EXPLANATION OF SIGNIFICANT DIFFERENCES TO THE RECORD OF DECISION FOR THE INTERIM REMEDIAL ACTION OF THE NORTHEAST PLUME AT THE PADUCAH GASEOUS DIFFUSION PLANT, PADUCAH, KENTUCKY, DOE/LX/07-1291&D2/R1, AND REMEDIAL ACTION WORK PLAN FOR OPTIMIZATION OF THE NORTHEAST PLUME INTERIM REMEDIAL ACTION AT THE PADUCAH GASEOUS DIFFUSION PLANT, PADUCAH, KENTUCKY, DOE/LX/07-1280&D2/R1

**Explanation of Significant Differences
to the Record of Decision for the Interim Remedial Action
of the Northeast Plume at the
Paducah Gaseous Diffusion Plant
Paducah, Kentucky**

**DOE/LX/07-1291&D2/R1
Primary Document**

Date Issued—August 2015

Figure 5. Locations of New and Preexisting EWs Associated with the Northeast Plume IRA at PGDP

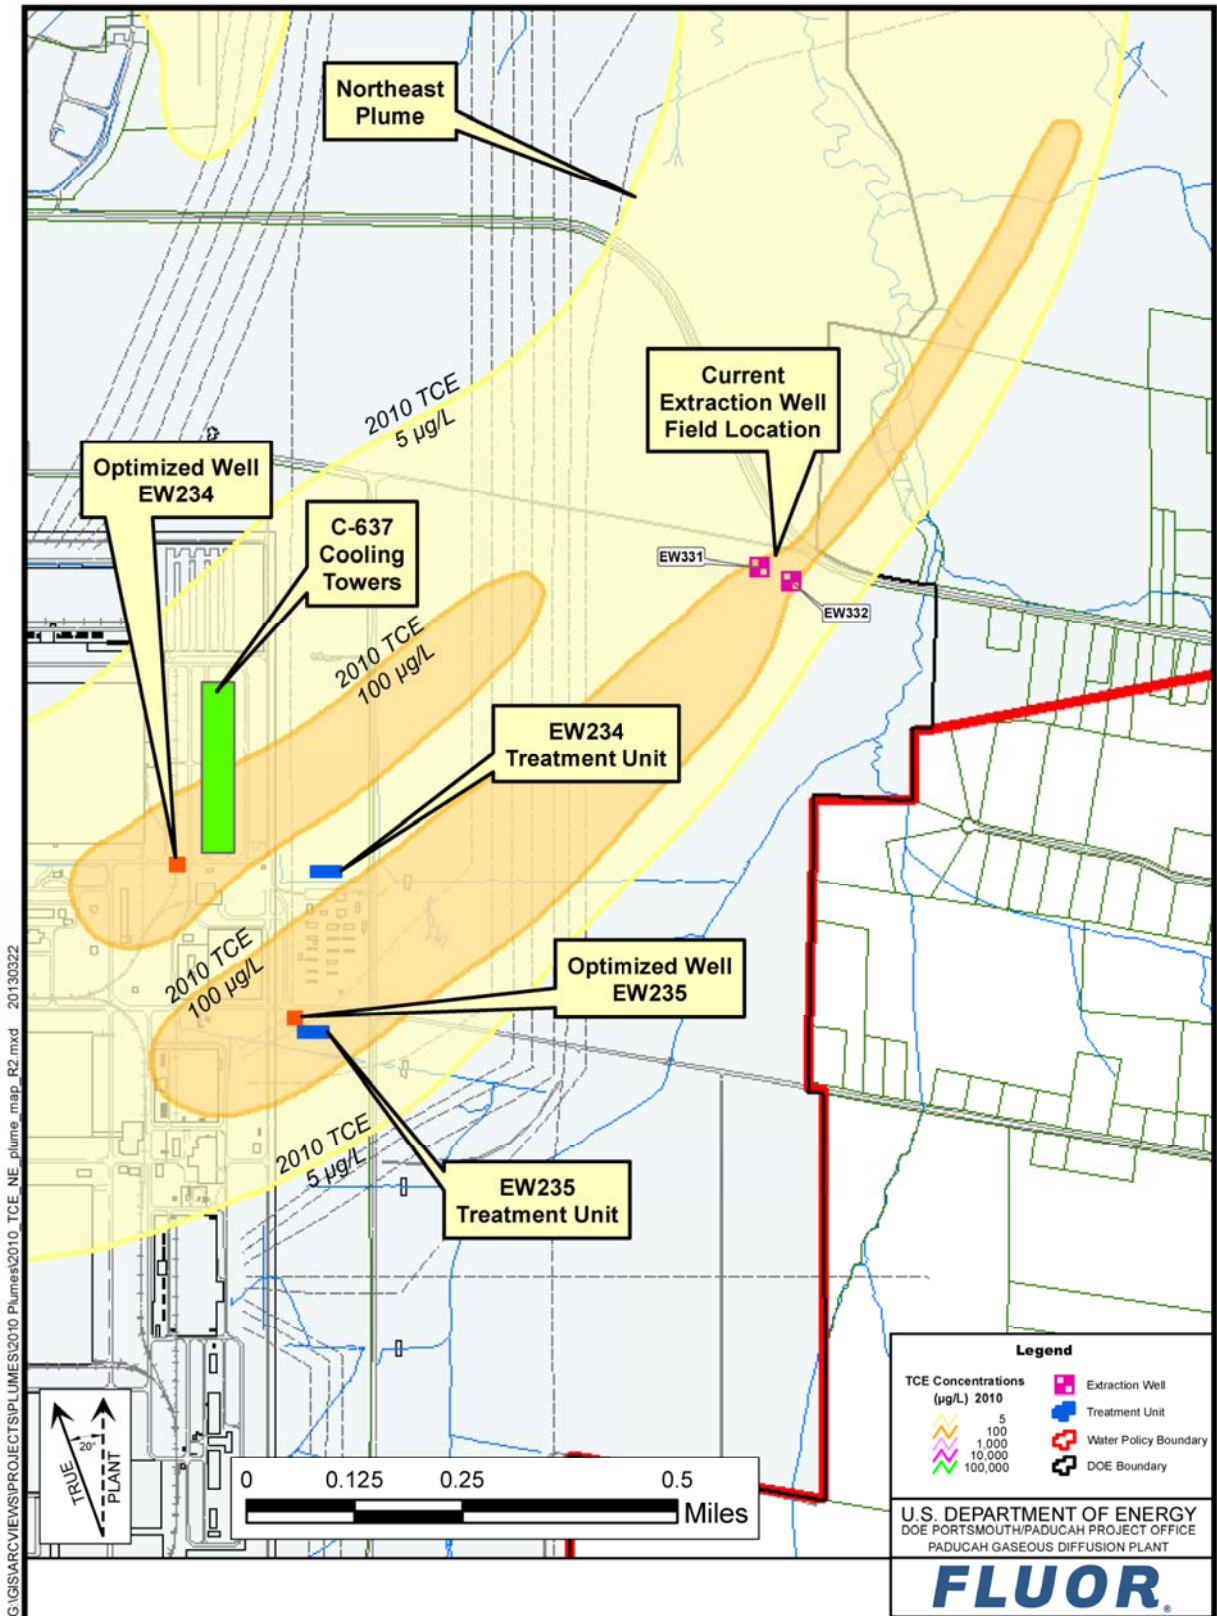
- Northeast Plume EWs (EW234 and EW235) will be located near the eastern edge of PGDP and the existing EWs (EW331 and EW332) will be kept in good working condition until the FFA parties agree the maintenance no longer is necessary.

Well field optimization modeling indicates that a two-well configuration is optimal. The two new wells, EW234 and EW235 based in part on groundwater modeling, are to be located near the eastern edge of the PGDP facility. Refer to Figure 5 for well locations. The EWs (EW234 and EW235) are expected to have an operational flow rate of approximately 150 gpm each. Detailed lithologic logs and grain size analysis to the extent available will be used in well screen and filter pack design of the new EWs (EW234 and EW235). Once the two optimized EWs are online, contaminant concentrations in samples from the transect wells will be collected on a quarterly basis and reported to EPA and KDEP. If contaminant concentrations in any transect well's quarterly samples are determined to be increasing and may double above the established baseline within a year of the quarterly samples' showing an increase, then potential changes in groundwater flow or source impacts (e.g., rising contaminant concentrations in the Northeast Plume, source migration, etc.) will be examined further. The FFA parties will consider adjustments (e.g., adjusting EW pumping rates) for the optimized Northeast Plume interim action to minimize these potential impacts. These adjustments are considered within the scope of the optimization under the ESD.
